# Recommendation for City of Oberlin's Intersection Control Beacons

# Peer Review and Collaboration

## E. Lorain Street/FAA Entrance

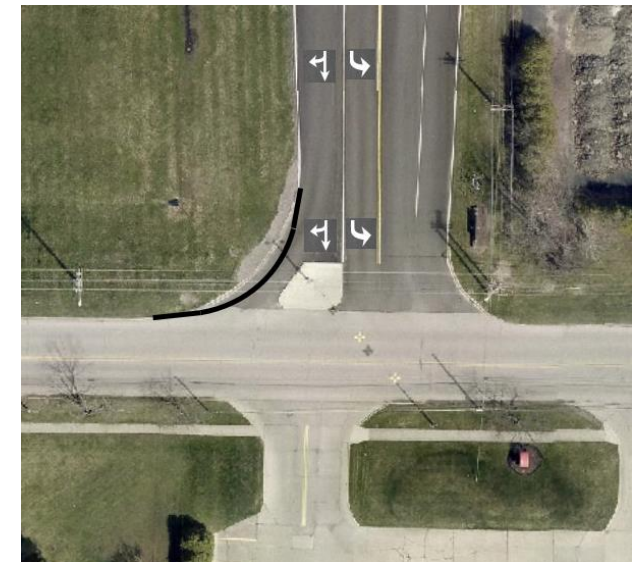
- We concur with recommendations.
- Lining up the FAA and IGA driveways as much as possible is a good idea.
- Adding stop signs and Cross Traffic Does Not Stop are good ideas.
- Existing pole holds two streetlights. The City should consider relocating the streetlights if the lighting is needed at the intersection.

Note: After sharing the report and recommendations, on Sept. 13<sup>th</sup>, FAA confirmed that they had no further questions and no objections to the proposed decommissioning of the ICB at this location.

## E. Lorain Street/Oberlin Road

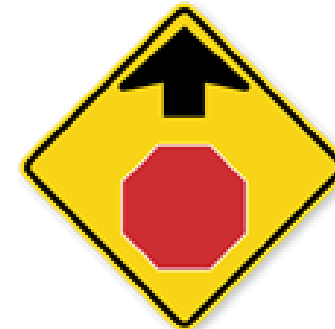
- We concur with the recommendations to remove the ICB.
- Two lane approach to a stop condition seems to add to confusion for the drivers and is generally something we have tried to avoid recommending. Two vehicles at the intersection simultaneously could impede sight lines. Is there a need for these the two left turn lanes? Do the turning movement counts support the existence of these turn lane?

Note: The left turn lanes were added after a 2000 Traffic Analysis recommended the turn lanes to improve the level of service at this intersection. GPD did not have this report.
